# **Stonestreet Green Solar Project**

**Planning Inspectorate Reference: EN010135**

**Deadline 1 Written Representation by**

**CPRE Kent**

**Provisional Agricultural Land Classification (CPRE Kent)**

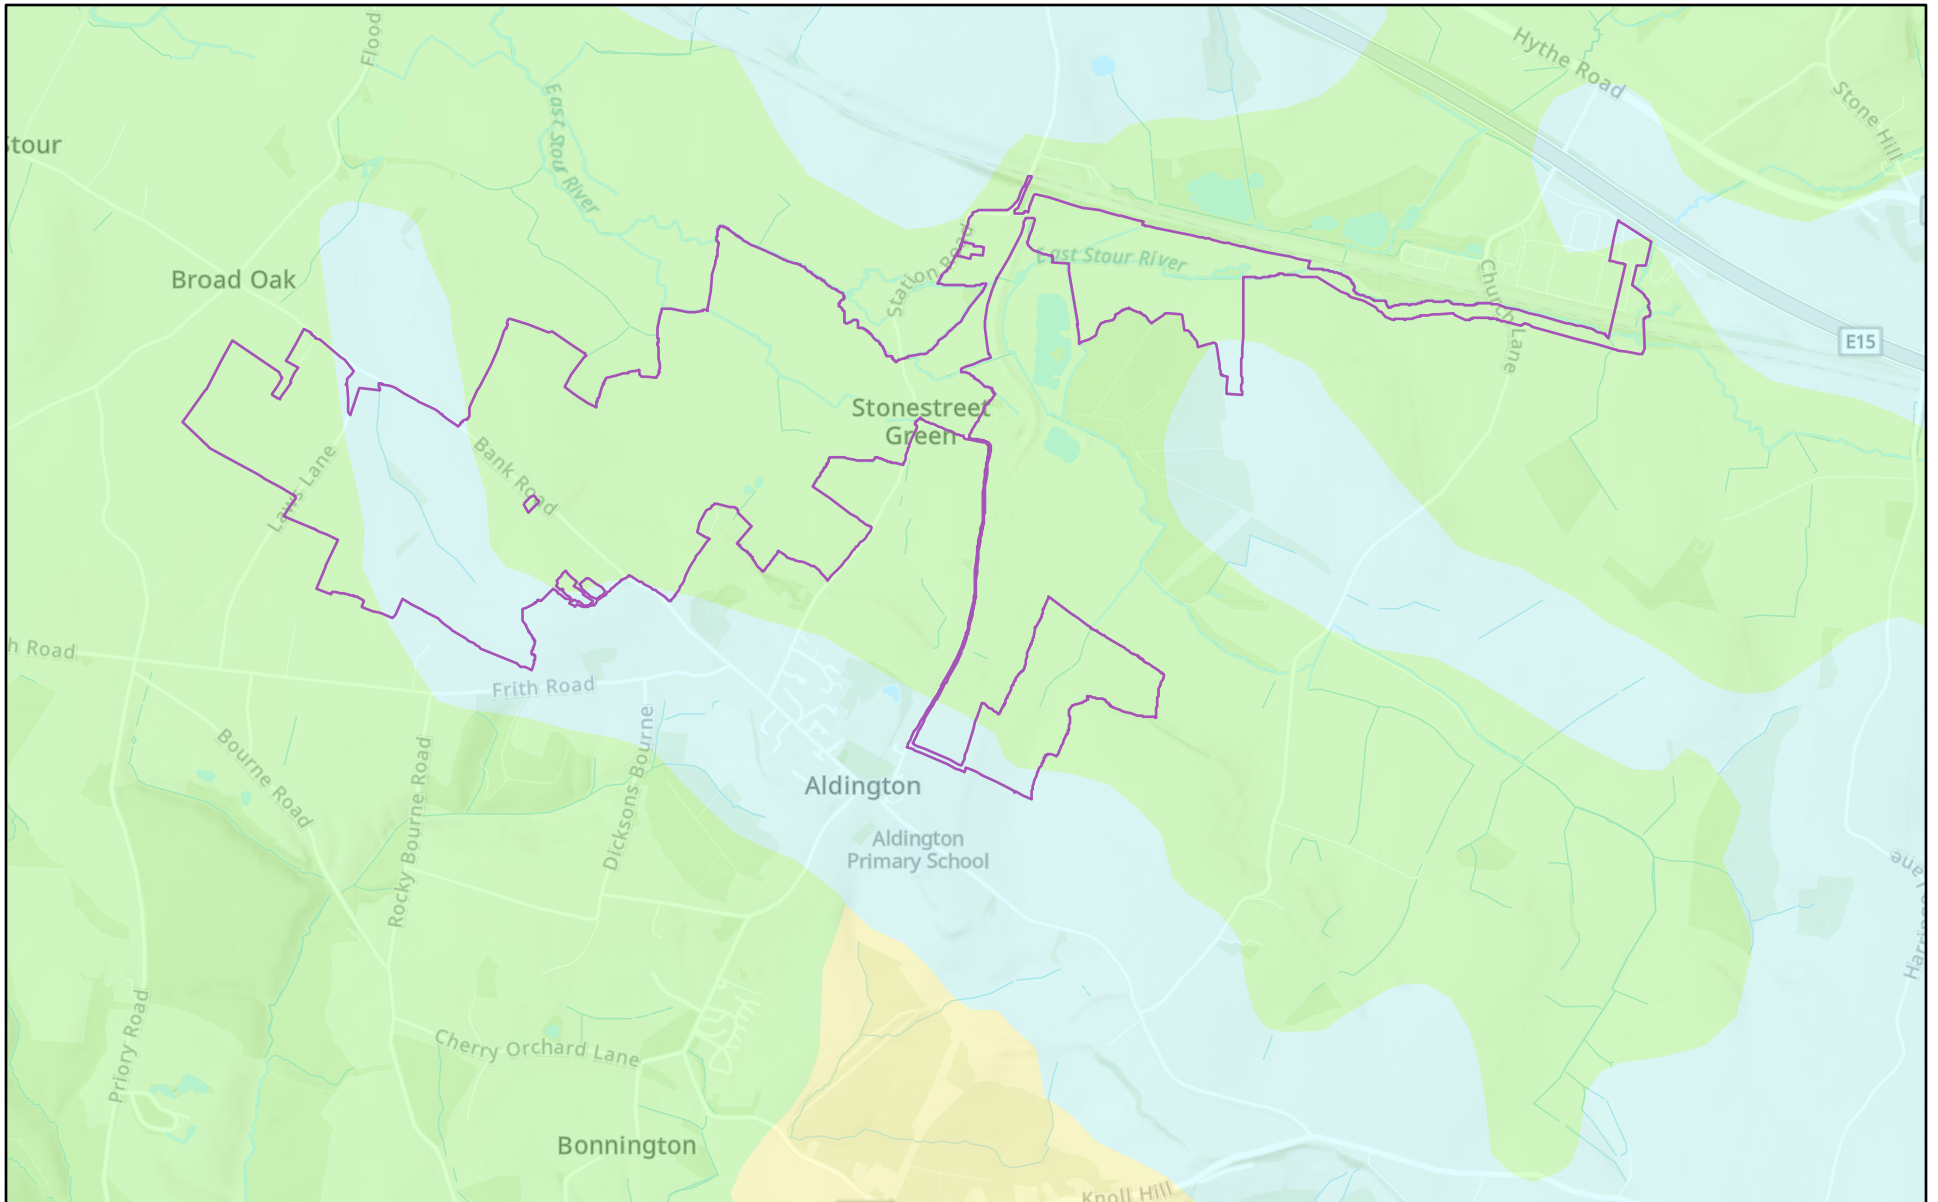
- 6.9 As indicated by the below map based on Natural England's Provisional Agricultural Land Classification Grade dataset (and provided at full scale within Annex 1), there are significant swathes of Grade 2 land across the southern section. Notably, this includes field 20.

- 6.10 It is recognised that Natural England's Provisional Agricultural Land Classification Grade dataset does not differentiate between Sub-grade 3a (good quality, BMV) and Sub-

grade 3b (moderate quality, non-BMV) and therefore does not accurately identify the coverage of BMV land.

- 6.11 Consequently, while it is noted a map (Reference GM12014/002 APFP 5(2)(a)) has been provided within the Environmental Statement Chapter 16 Appendix 16.1: Soils and Agricultural Land Report (APP-122), this is not easy to interpret, nor does it give a clear indication as to how the soil types interact with the proposed built infrastructure. We therefore note and support the comments made by Natural England in this respect.
